Re: Annual Report: Permit NM-02-0007
BP Cahn Waste Management Facility
NW/4 Sec. 33 - T32N - R10W, San Juan County, NM

**RE: 711 Centralized Waste Management Facility Inspection
AMOCO Production Company, Cahn Evaporation Pond
NW/4, Section 33, Township 32 North, Range 10 West, NMPM,
San Juan County, New Mexico**

ATTACHMENT 1
INSPECTION REPORT
JUNE 11, 1997
AMOCO PRODUCTION COMPANY, CAHN
(NW/4, Section 33, Township 32 North, Range 10 West, NMPM,)
SAN JUAN COUNTY, NEW MEXICO

Re: Amoco Production Company
Cahn Waste Management Facility, SE/4 SW/4 Sec. 28 - T32N - R10W
NMOCD Rule 711 Application

AMOCO CHAN 711 FACILITY INSPECTION (PHOTOS BY OCD)

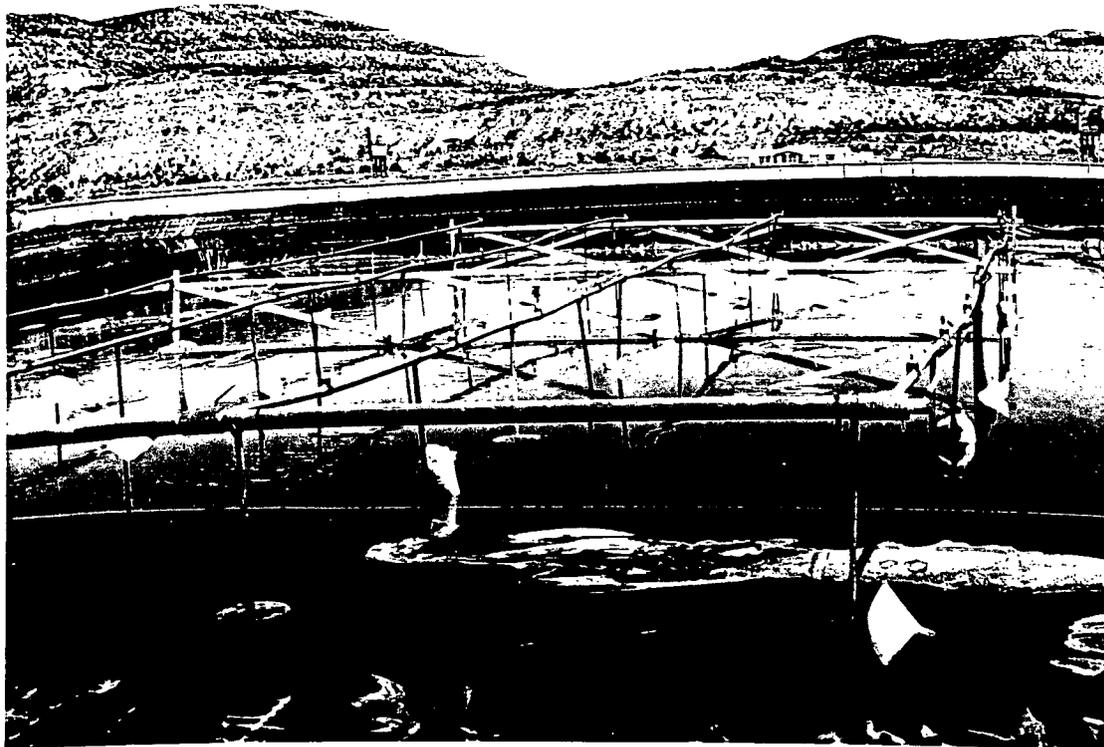
Overall yard maintenance practices at the facility were good. However, some tanks have overtopping stains (see picture 1). Stained soil around some tank valves is evidence that leaks have occurred. Spill collection sumps at tank valves should be pumped out regularly and inspected for leaks.

The berms around the above ground tanks need to be repaired (see picture 1) and modified to hold the appropriate volume. There is no berm requirement for the 8 (eight) green tanks that are designed to hold freshwater from the Freeze -Thaw Evaporation operation (see picture 2). If the operation changes and the tanks are used to hold fluids other than fresh water a berm must be constructed to hold the appropriate volume.

The above ground tanks are not appropriately labeled as to their contents or the hazards of the contents (see picture 1). Hazard placards are required on all above ground tanks not containing fresh water.

The facility tanks had some overtopping stains (see picture 1). Overall yard maintenance and spill prevention/cleanup was good.

1. Pond Freeboard: A pond freeboard marking device will be installed prior to June 1, 1998. Presently, freeboard is well below the 1.5 foot minimum requirement. This level is not expected to be approached prior to June 1, 1998.
3. Leak Detection System: The leak detection system will be inspected quarterly and sampled annually for comparison with fluids in the pond.
4. Sludge Build-up: Sludge thickness in the base of the pond will be measured annually.
6. Signs: A clearly labelled sign is in view within 50 feet of the facility.
8. Process Area: The process tanks at the facility have been taken out of service and are scheduled to be removed from the site prior to December 31, 1998.
9. Above Ground Tanks: As indicated above, the process tanks have been taken out of service and are scheduled to be removed from the site prior to December 31, 1998. Therefore, no berm repair

12. Tank Labeling: As indicated above, the process tanks have been taken out of service and are scheduled to be removed from the site prior to December 31, 1998. Therefore, no tank labelling is necessary.

15. Housekeeping: As indicated above, the process tanks have been taken out of service and are scheduled to be removed from the site prior to December 31, 1998. Therefore, no tank overtopping can occur.
